_	Case No.:	
Fee: \$750.00	MAR 2 8 2023	Date File	l:
	Zoning Board of Ap Village/Town of Mount		
	Village/Town of Mo		
	Municipal Buil		
	104 Main Street, Mt. Kiso	co, NY 10549	
	Zoning Board of A		
	Application	1	
Appellant: DP 21, LLC			
	ford Road, Suite 145, Moun		
Address of subject proper	rty (if different): 333 Nor	rth Bedford Road, M	ount Kisco, NY 1054
Appellant's relationship t	to subject property: X	Owner Les	ssee Other
Property owner (if different Address:	ent): Same as above		
	ZONING BOARD OF AP Building Inspector, <b>Peter</b>		
dated 09/06/2019	. Application is hereby	made for the follow	ving:

WITHIN 1,470± SF TELECOMMUNICATIONS

SITE 180 S. BEDFORD RD. ADDRESS: MT. KISCO, NY 10594

**ELEVATIONS**

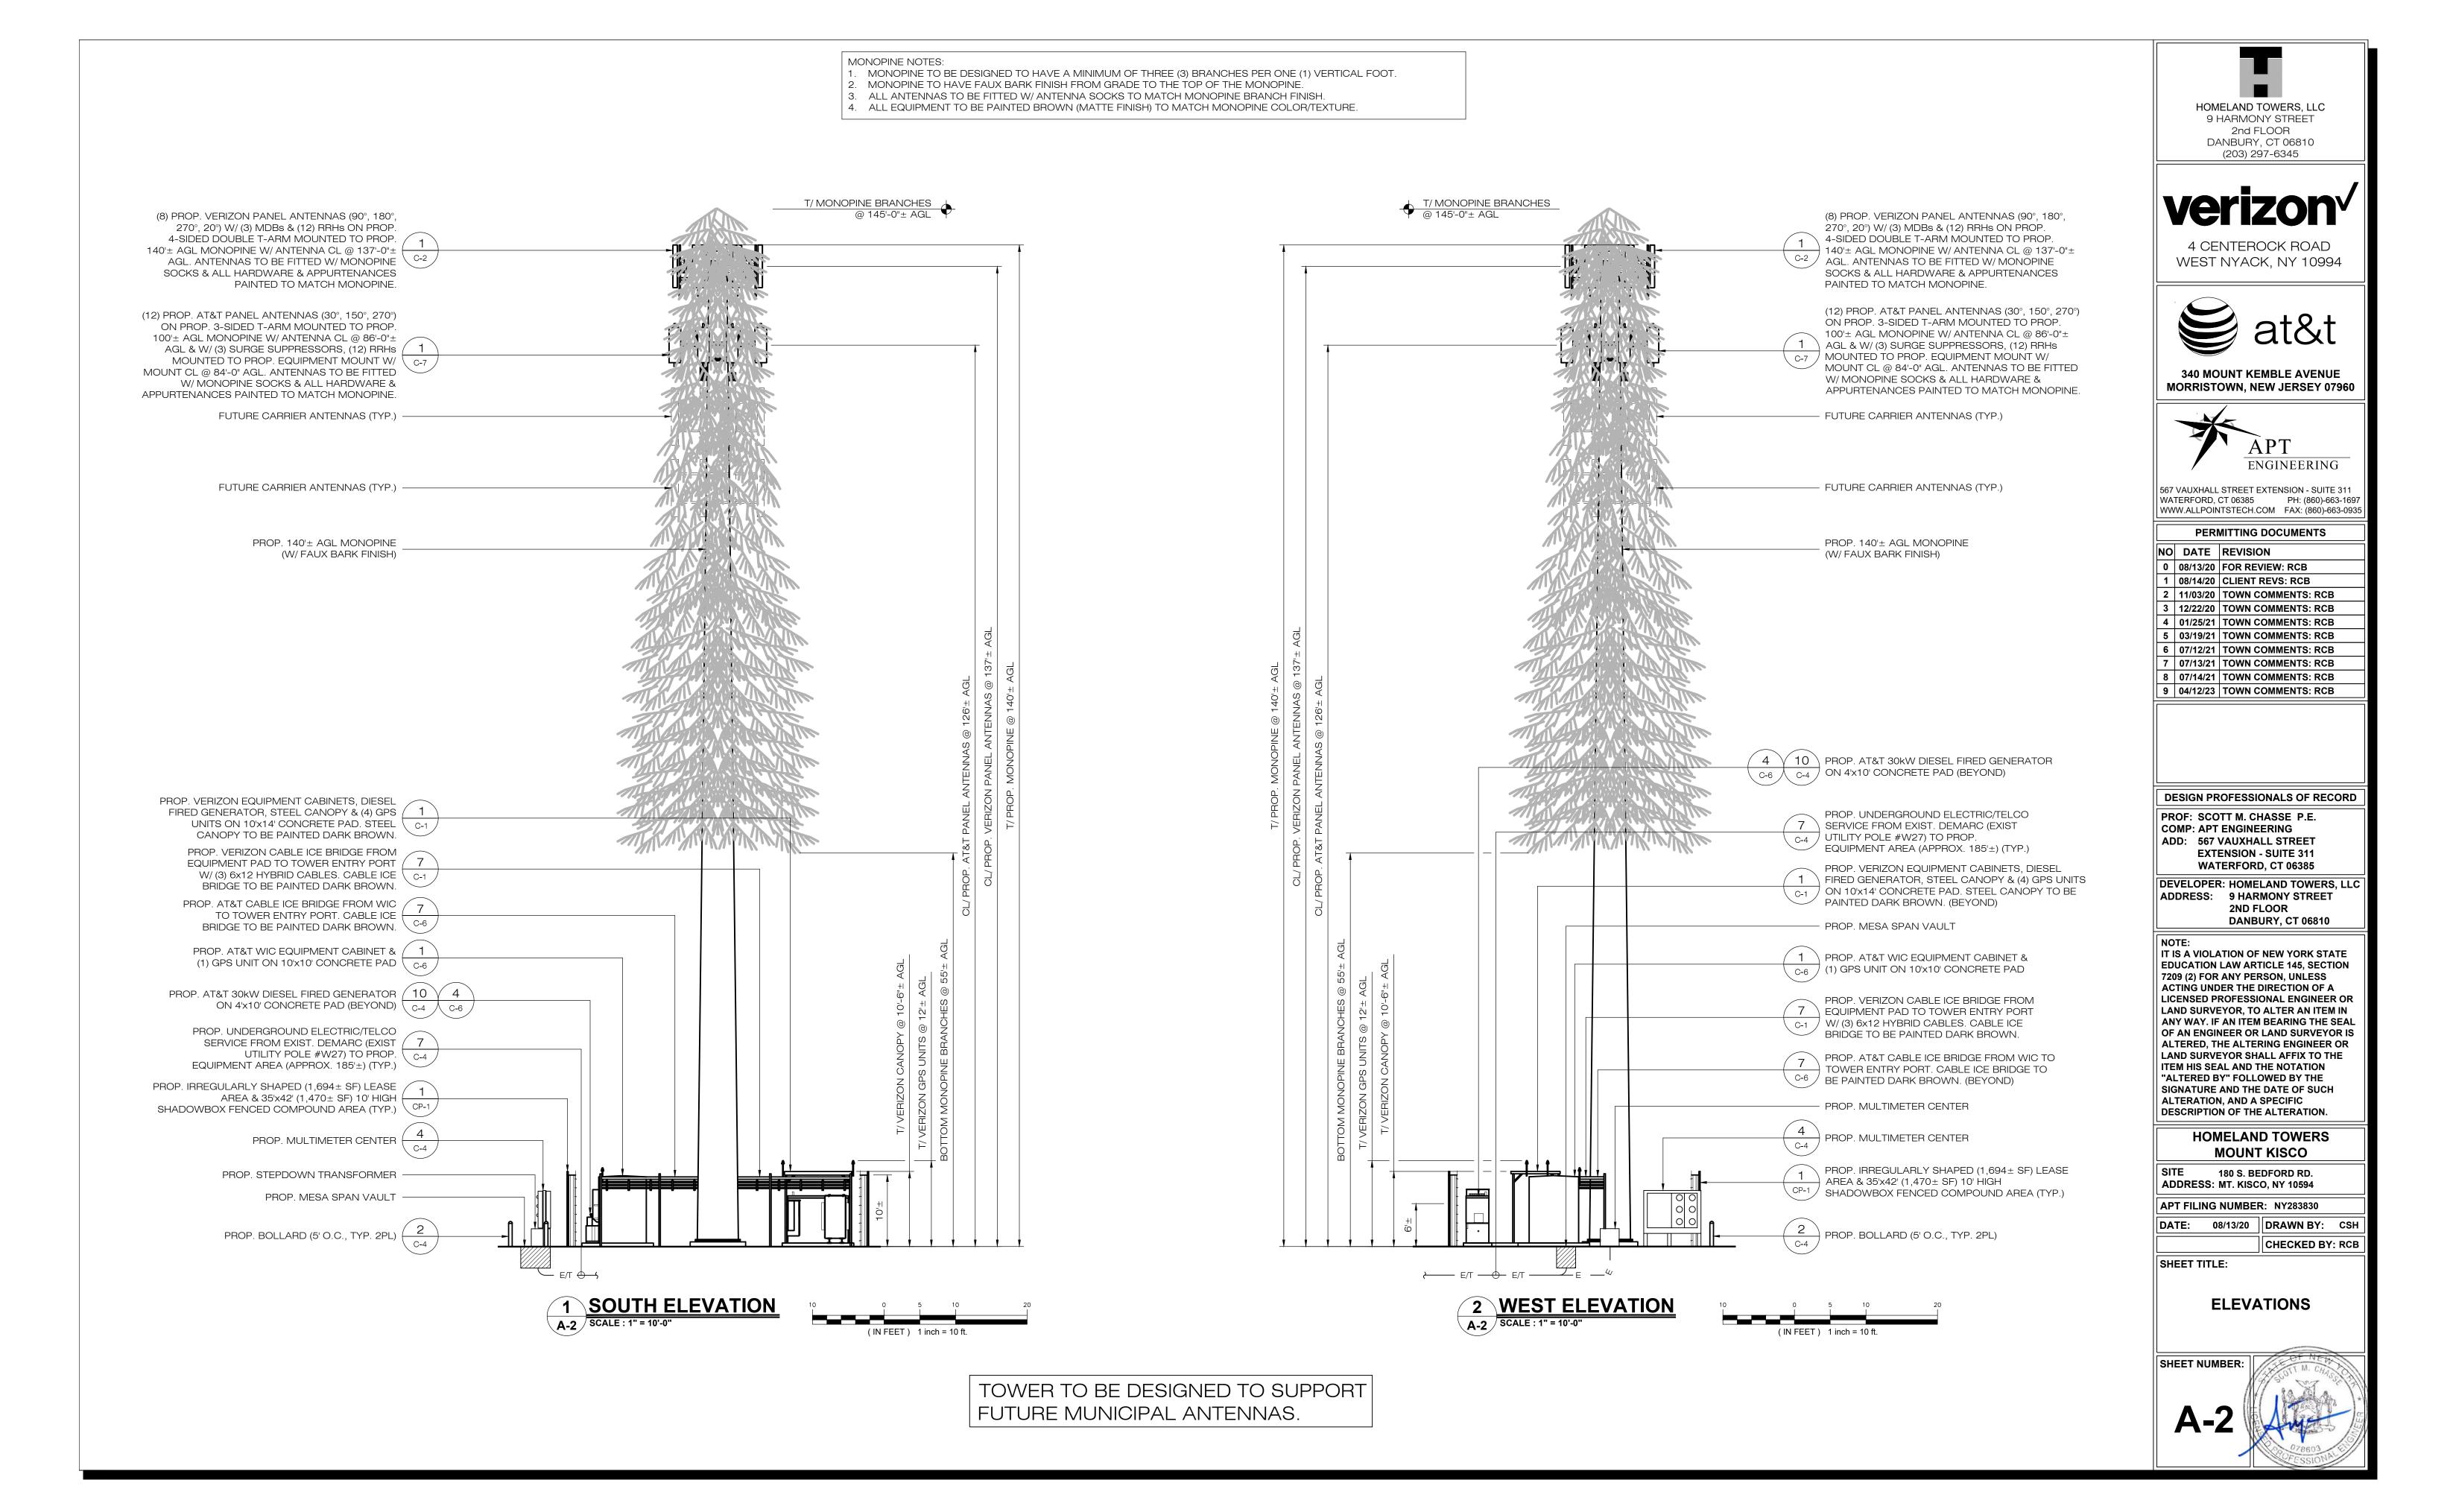
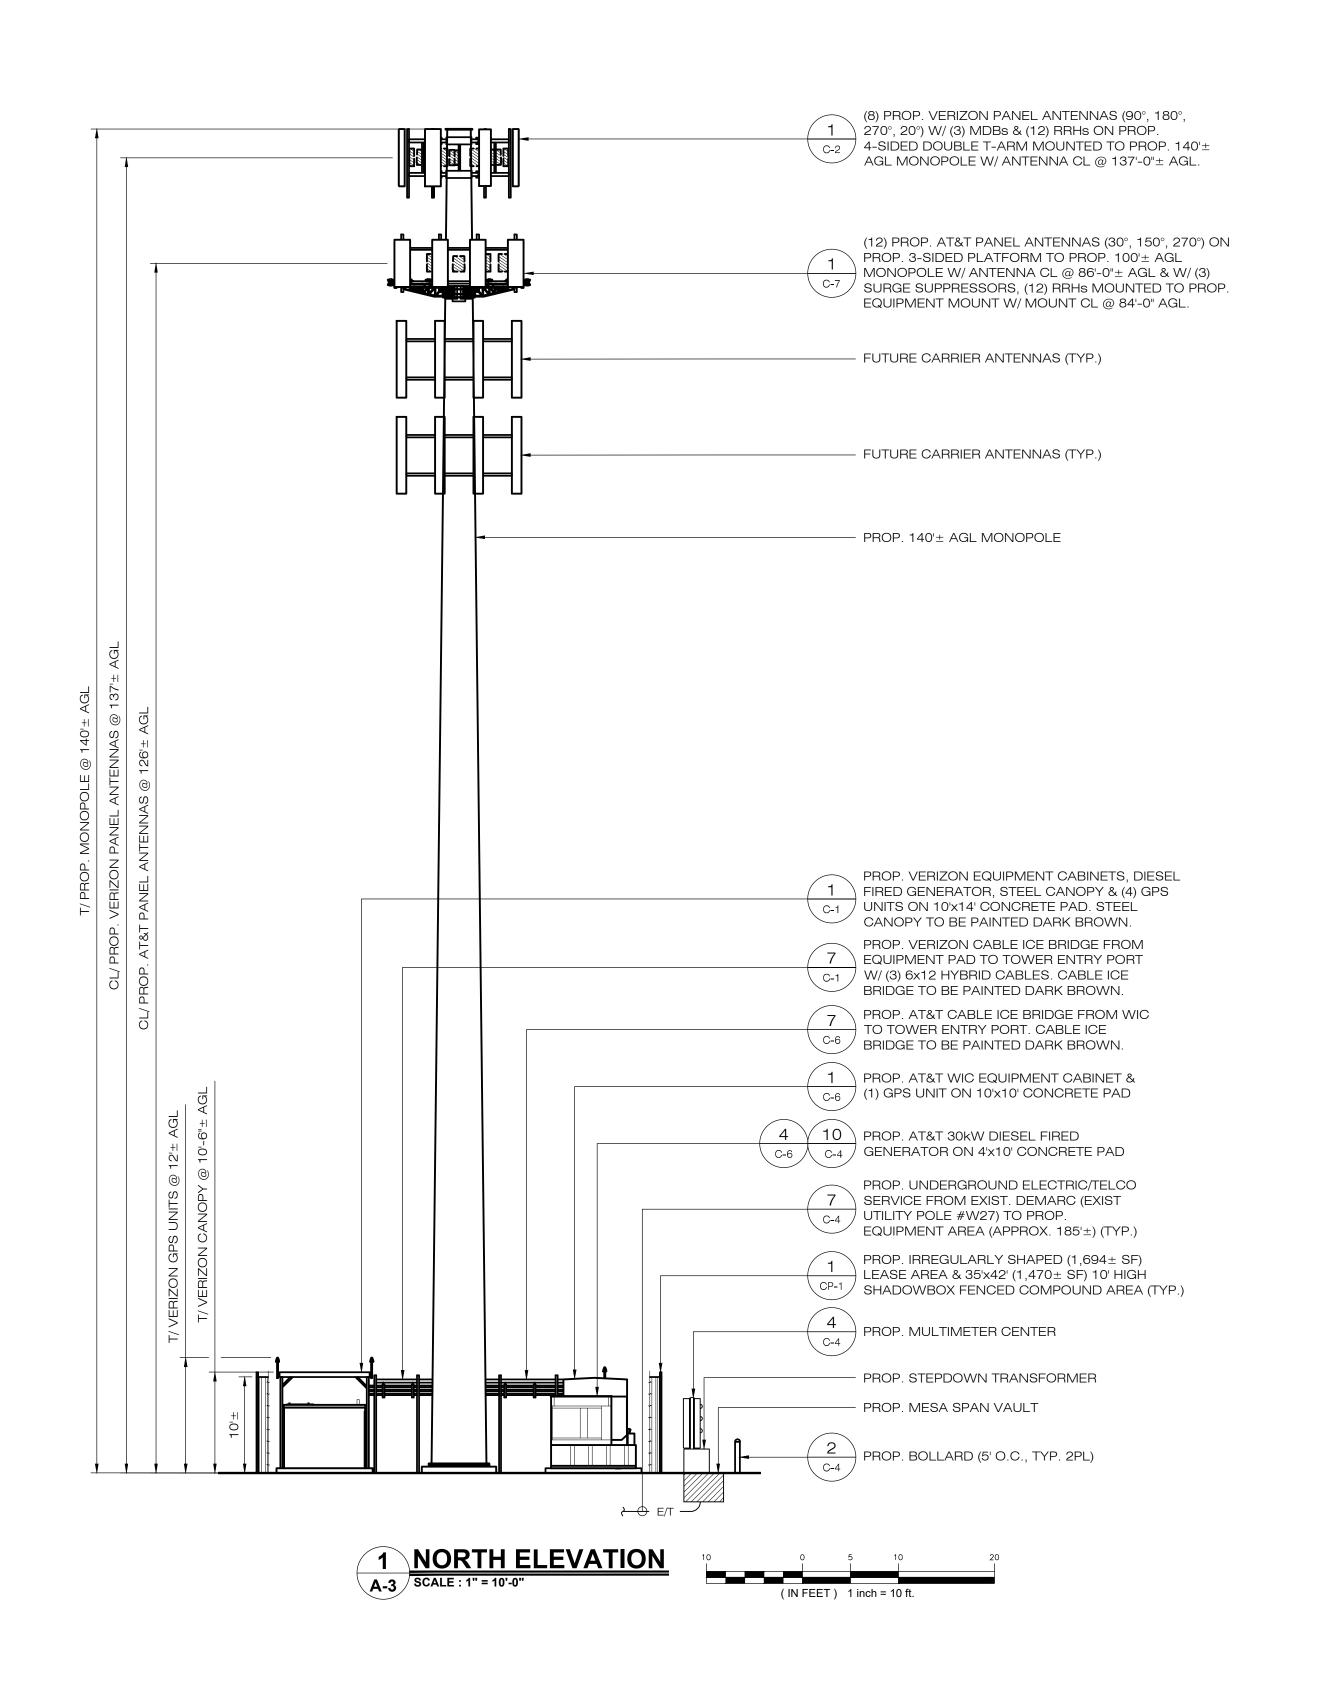
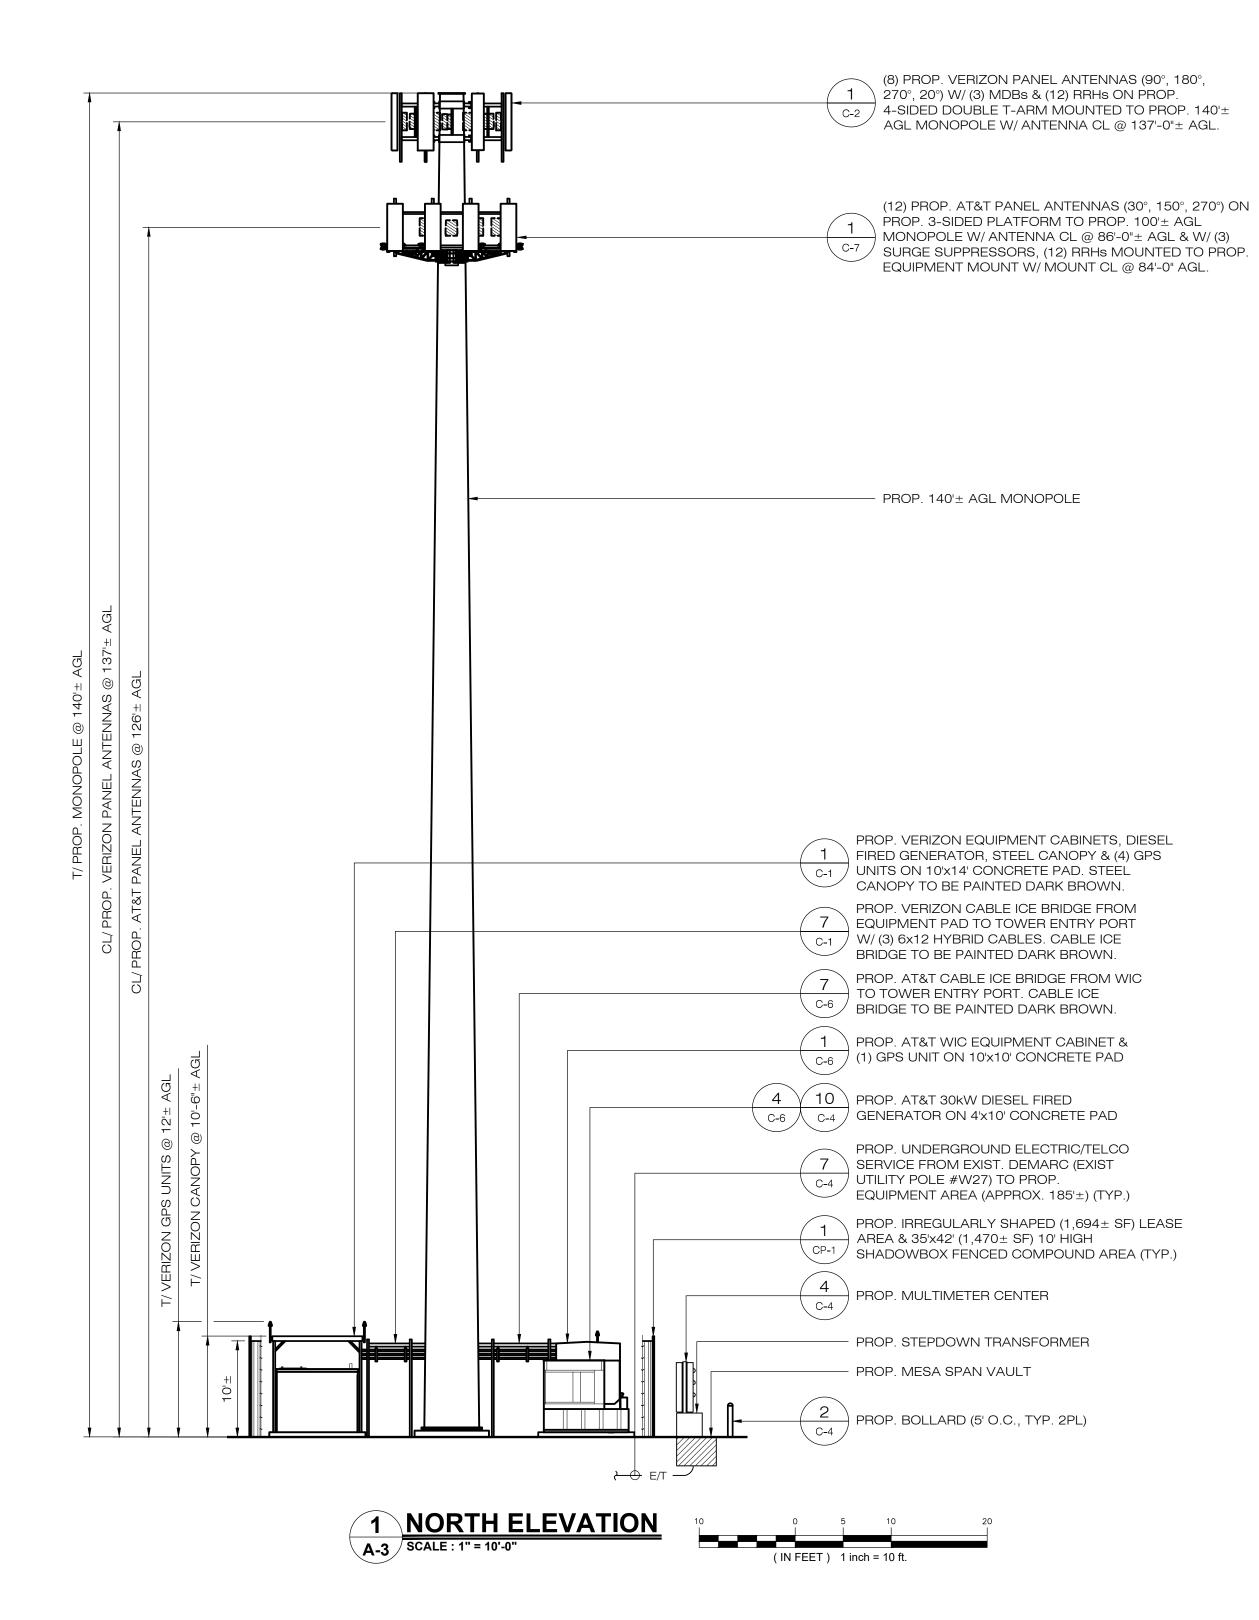
- Design criteria of branch density, taper of branches, and maximum feasible extension of branching downward toward the base of the monopole should be implemented. The density of branches shall be at a minimum of three branches per foot. The Site Plan Drawings now show branching extending from 5 ft above the top of the monopole (145 ft above grade level [agl]) down to 70 ft agl; it is recommended that the design extend the branching further downward to 55 ft agl. A note addressing the branch density of (3) branches per foot has been added to the Drawing A-1 & A-2. The Tower elevations have been revised to extend the monopine branches from 70' AGL to 55' AGL (Drawing A-1 & A-2).

- Monopole texture / color. Faux bark (brown, matte finish) shall be applied to the monopole exterior from grade level to the top of the monopole (entire structure).
   The Drawings have been revised to specify a faux bark finish to the proposed monopine (see Drawings A-1 and A-2).

Notes regarding the proposed monopine design have been added to Drawings A-1 and A-2.

The Drawings have been revised to specify a faux bark finish to the proposed monopine (see Drawings A-1 and A-2).
